PLEASURE LAKE DAM
NYS ID DAM
NO. 163-1597
NAT DAM ID NO. NY00345
SULLIVAN COUNTY
NEW YORK

TRANSMITTAL
EMERGENCY ACTION PLAN
PLEASURE LAKE DAM
STATE DAM ID# 163-1597
TOWN OF FALLSBURG
SULLIVAN COUNTY, NEW YORK

Transmitted herewith are three (3) copies of the revised Emergency Action Plan for the Pleasure Lake Dam. The Plan has been reviewed and updated to reflect the Department's July 31, 2007, review comments. Our responses to these comments are presented in this letter. To facilitate your review, NYSDEC comments are presented in **bold-faced type** and our responses are presented in regular type.

FIGURE 7-1

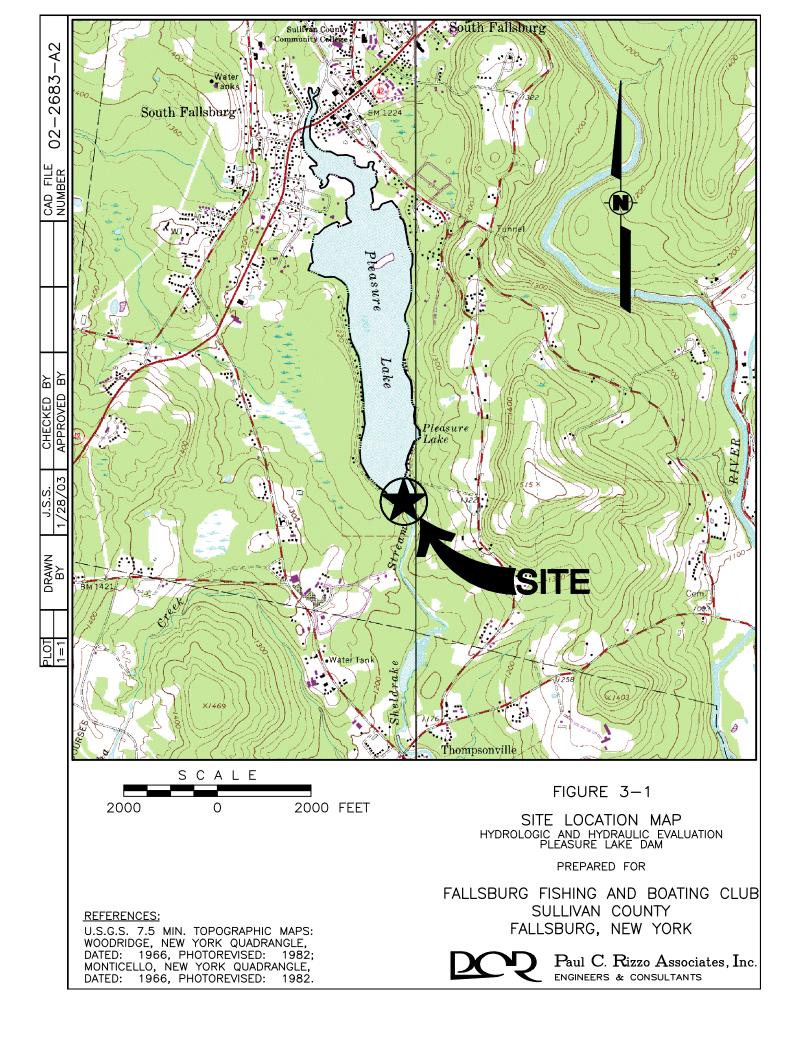
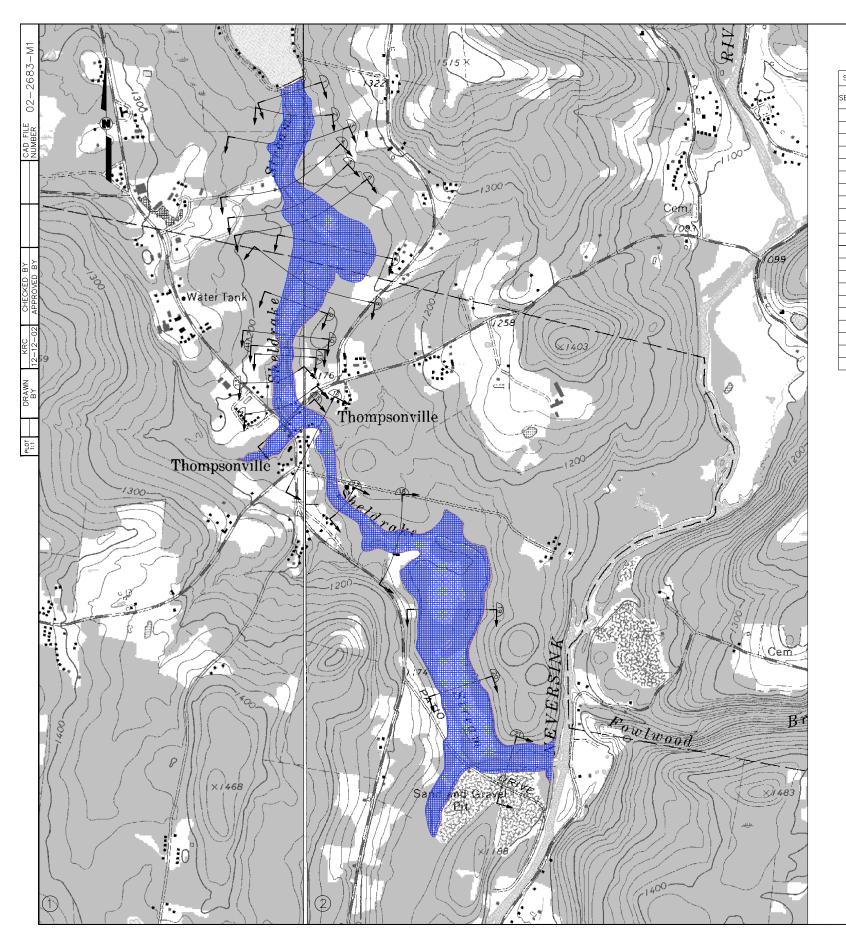
COMMENT NO. 13: Figure 7-1, Note 3 refers to dam break plus base flood. Does "base flood" equal to 100 year event, or the ½ PMF event? Also, has the inundation analysis been extended far enough downstream? Analysis should extent until the incremental rise between the non break and the dam break condition for each scenario is 2 feet or less.

RESPONSE NO. 13: The base flood is the Spillway Design Flood (SDF) for the Project which was selected by incremental analysis of the basin as submitted in the March, 2003, Hydrologic and Hydraulic Evaluation. The SDF for Pleasure Lake Dam is 0.4 PMF. Based on RIZZO's analysis as presented in the March, 2003, Report, a dam break under a 0.4 PMF condition causes a 0.1 foot increase in flood elevation at Thompsonville (see Table 3-7). The calculated water level at the confluence of Sheldrake Creek and the Neversink River due to a "sunny day" dam break is approximately El. 1100. There are three structures immediately downstream that may have some level of flooding. We suggest that these structures be investigated and if they are residences, they should be included in an updated version of the notification list.

ORGANIZATIONAL FLOW CHART AND LIST OF DOWNSTREAM RESIDENTS

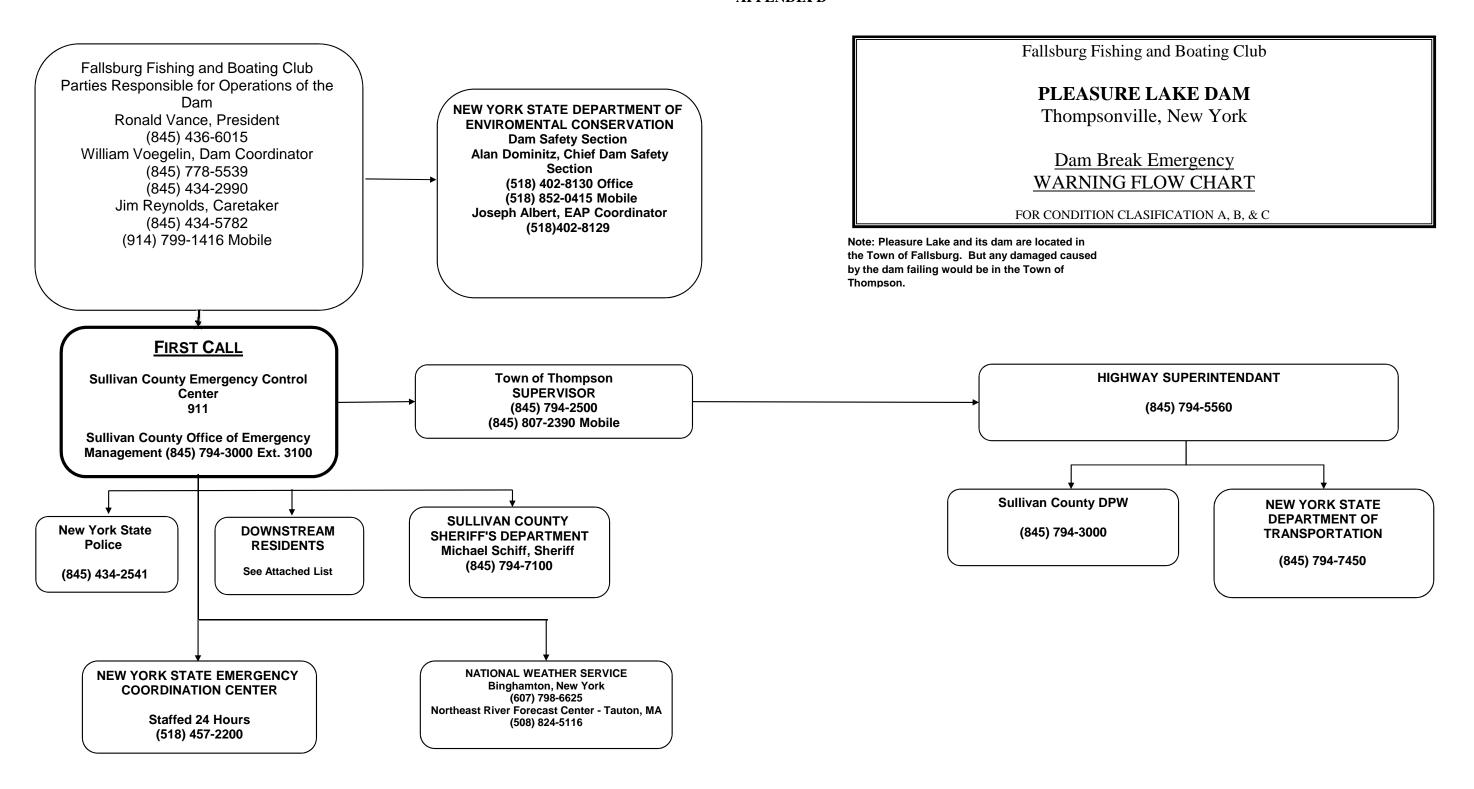
COMMENT NO. 7: Notification Flow Chart – Make it clear that the Club's first call should be the County EMC. In the upper DEC box, delete the words "Bureau of Flood Protection" and substitute therefore "Dam Safety Section". Also, Alon Dominitz should be listed first as the primary contact, with Joe Albert listed second as the backup. DEC only needs to be listed once on the flow chart, so consider deleting the lower box from the County EMC to DEC.

RESPONSE NO. 7: The requested changes have been made to the notification flow chart.
